DLNR-DAR RFI Questions:

1. Kona

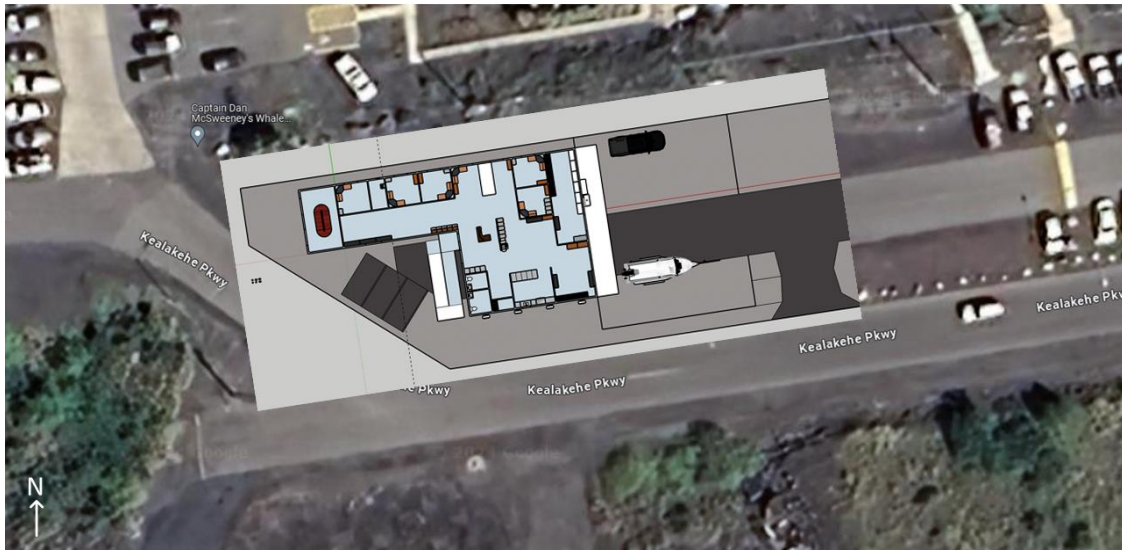
- b. Can you confirm the orientation of the new modular building on the site?

i. The exterior deck in both the 3200 and 4000 ft<sup>2</sup> versions are oriented in an approximate N-S direction along the eastern edge of the building. Please see the images below for the rough orientation. These images are not exact, however. The vendor should determine final precise locations based on installation and structural needs.
